ADA Curb Ramp New Construction Inspection Form (Parallel)

NW Timeric

23885.56

PARALLEL RAMP (PL)

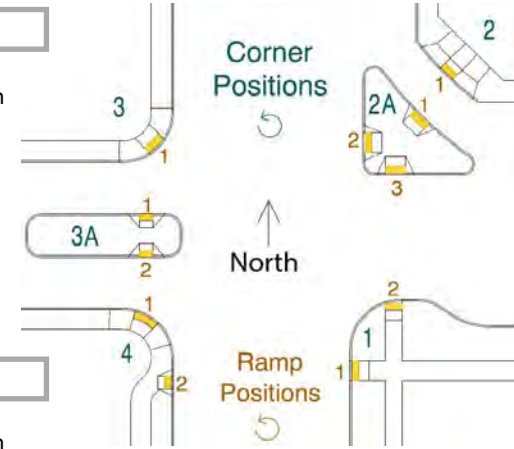
4.3 $\leq |5.0\%|$ ☐ $> |5.0\%|$ ☒

7.1 $\leq 2.0\%$ ☐ $> 2.0\%$ ☒

5.7 $\leq 2.0\%$ ☐ $> 2.0\%$ ☒

3.85 $\geq 4.0'$ ☐ $< 4.0'$ ☒

NTD RR1 TS Fail
